RE: Addendum #1 24-40 Bay County Jail Substance Abuse Unit Re-bid.

Please accept this as Addendum No. 1 for the above referenced solicitation.

RE: Structural Letter for RFI's
103 W. 5th St., Panama City, Florida

BAY COUNTY JAIL SUBSTANCE ABUSE UNIT

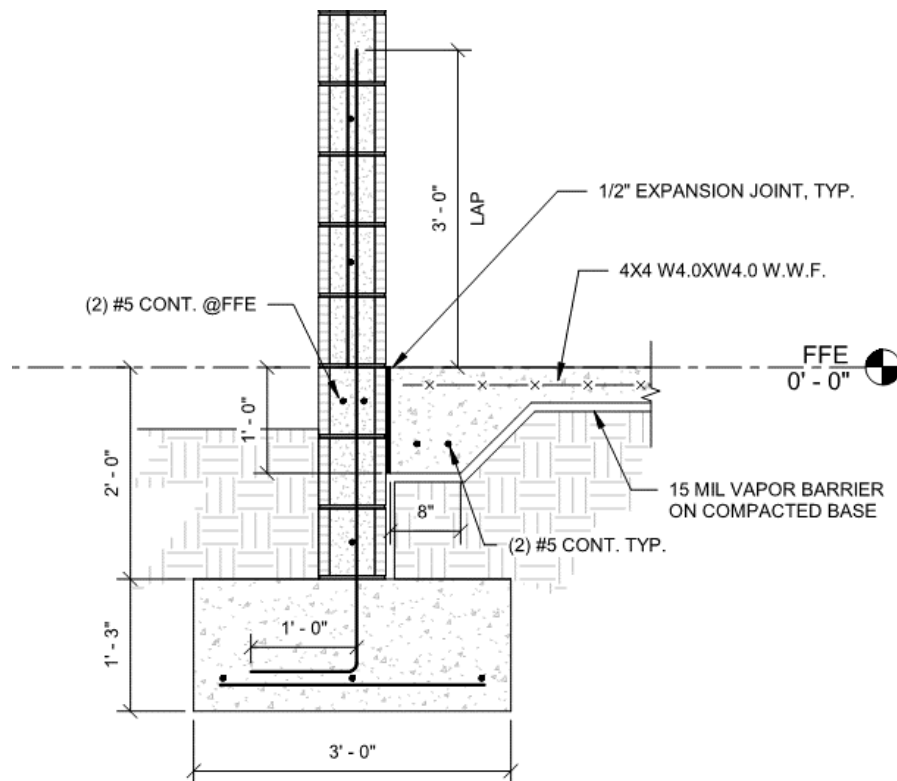
- Structural wall detail shows grade at FF level. Grade will be 6-8" below FF. Please verify you have enough cover.

Yes, this is acceptable.

6A WALKWAY SECTION
3/4" = 1'-0"

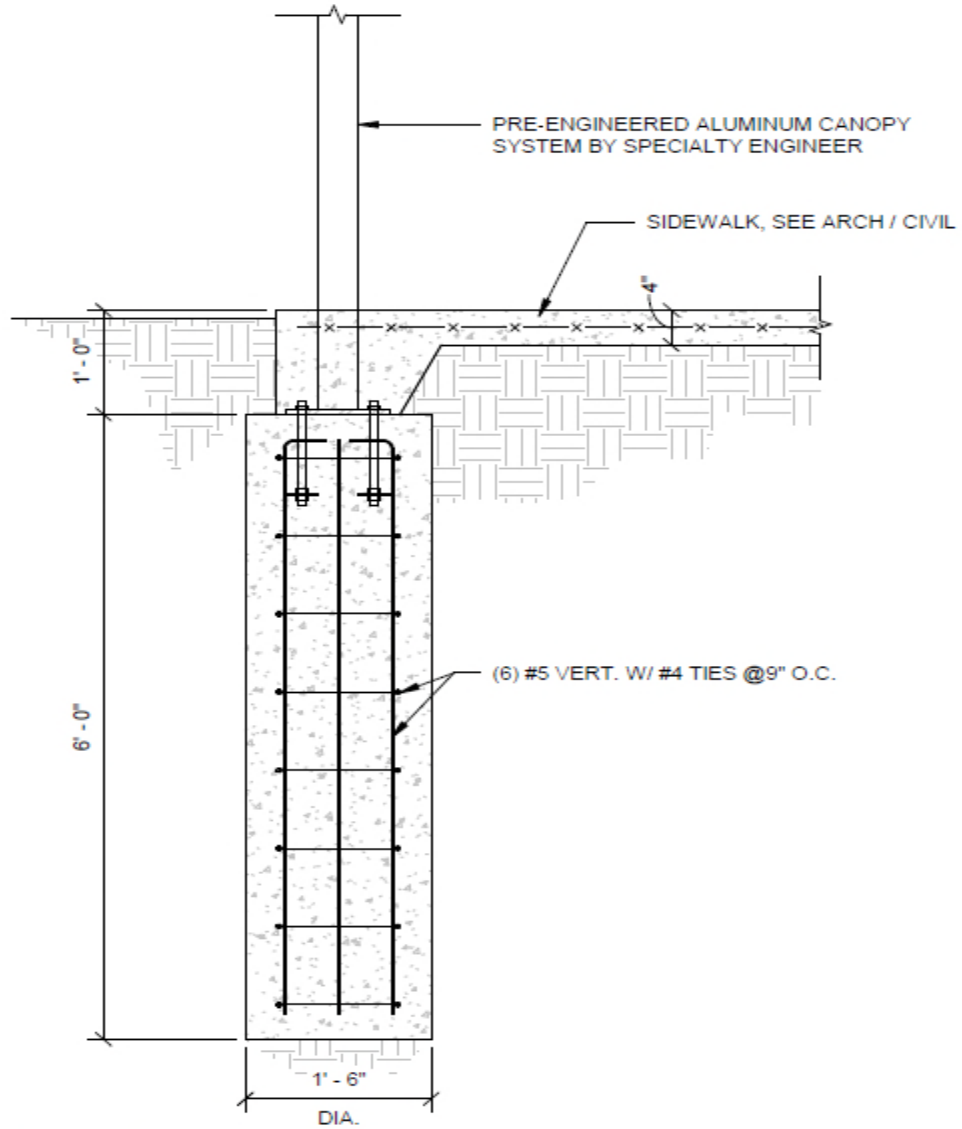
- Walkway canopy – we need to separate the base of the canopy post from the concrete with a protective barrier. Is the walkway slab figured into the uplift, or do the 6ft footings carry it all?

The slab was included in the weight for the uplift.

⑦ **BASE PLATE DETAILS**
1" = 1'-0"

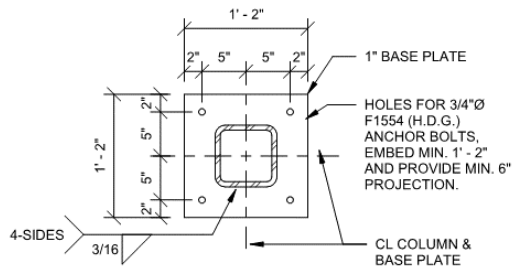
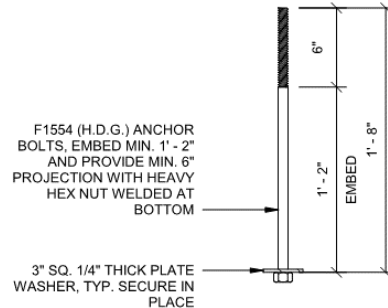
4. Is there a detail for the HSS base plates (plate size, anchor bolt size, etc)?

See details below, added to sheet S3.00

⑧ **ANCHOR BOLT DETAIL**
1 1/2" = 1'-0"

6 SECURITY GATE
 3/8" = 1'-0"

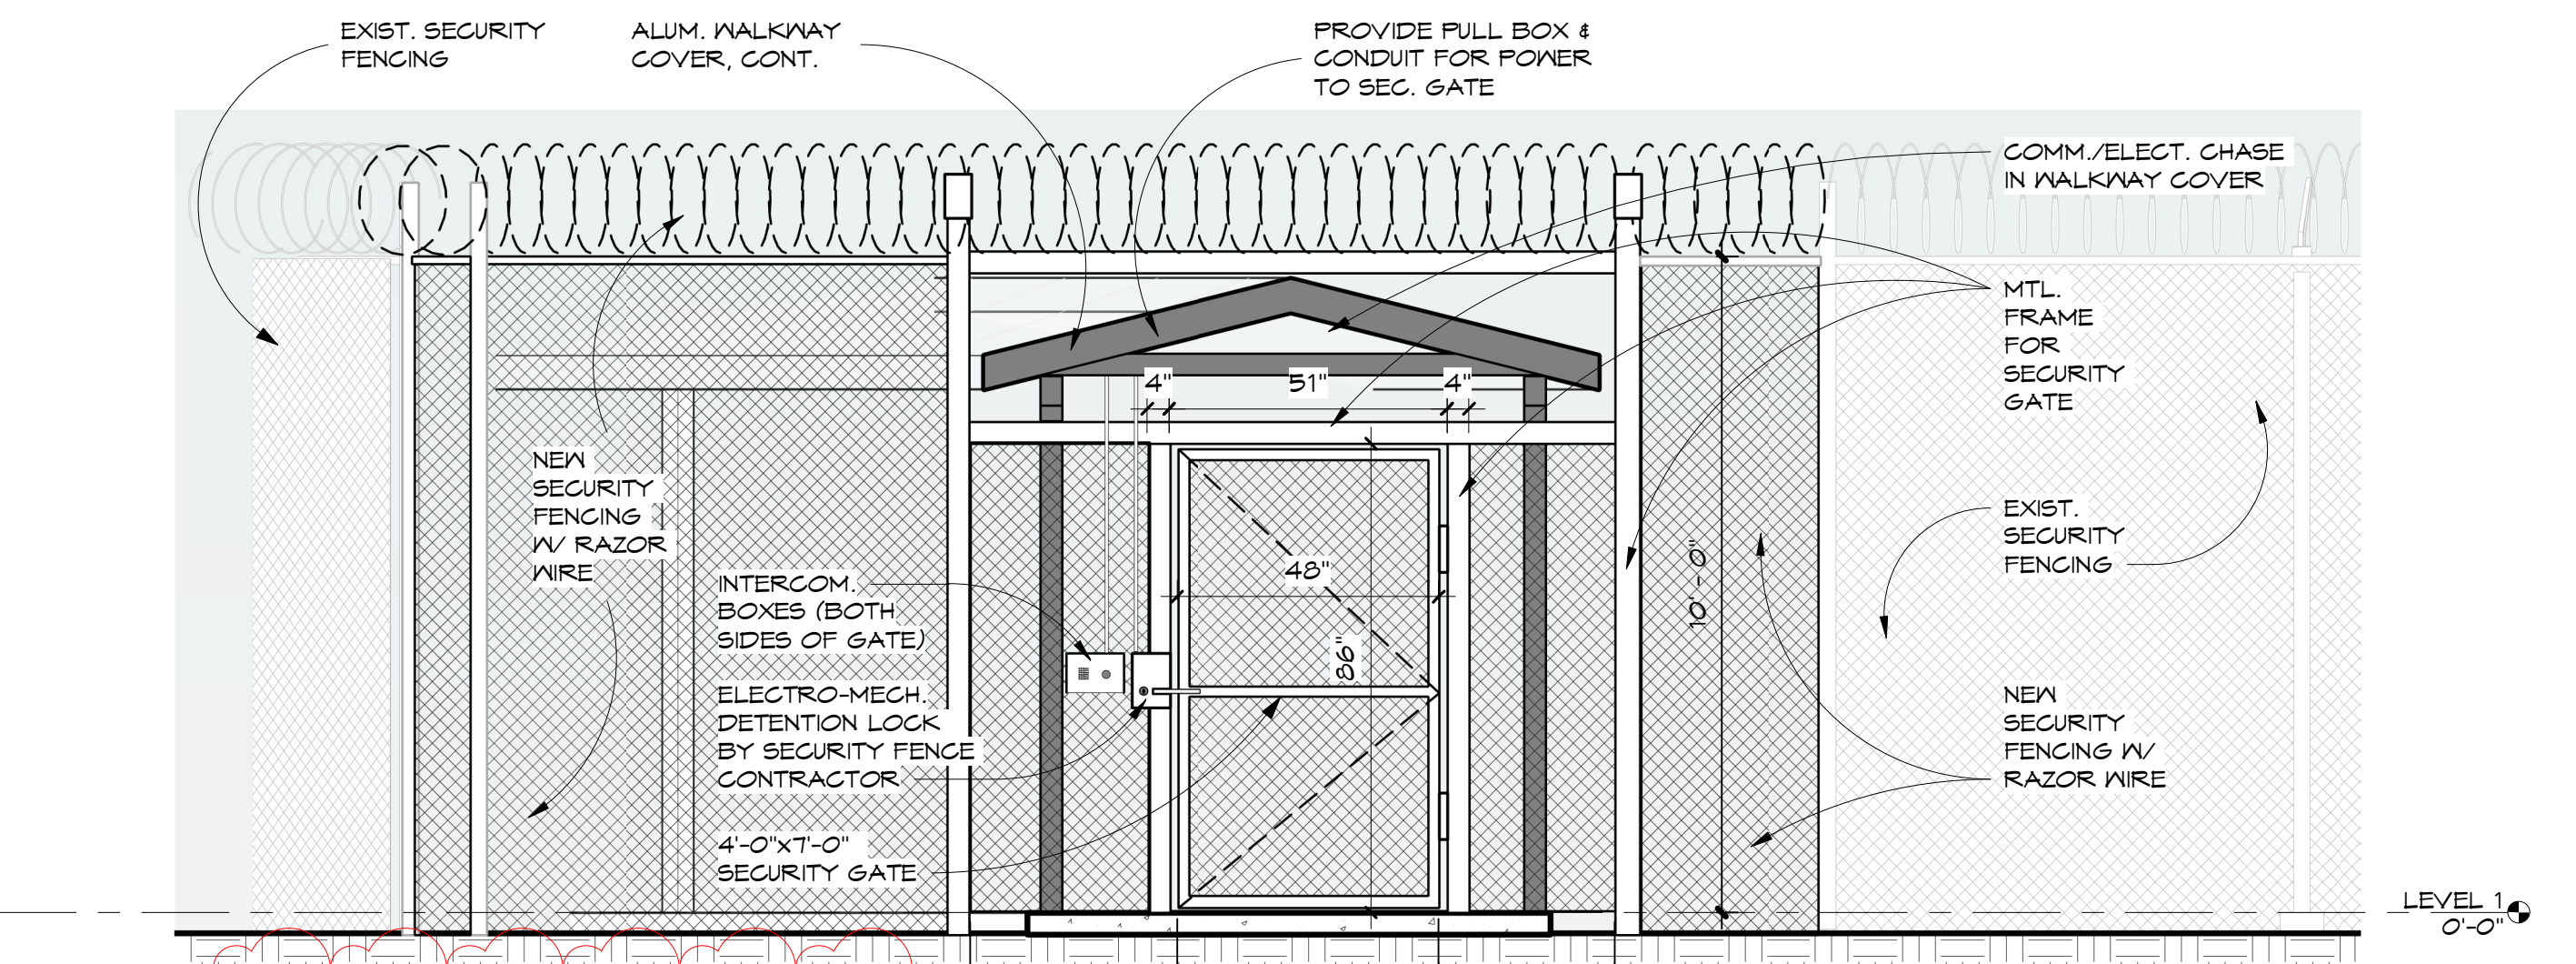
3. In the plans provided I have not been able to find the sheet where it calls out a new gate anywhere. I have the removal of approx. 24LF from the walkway, I have the two ends of the new building, receiving new 11' + 1 security fencing. Can you provide information for the gate? How wide? Any specific hardware required? Information provided in revised plan sheet which has been attached.
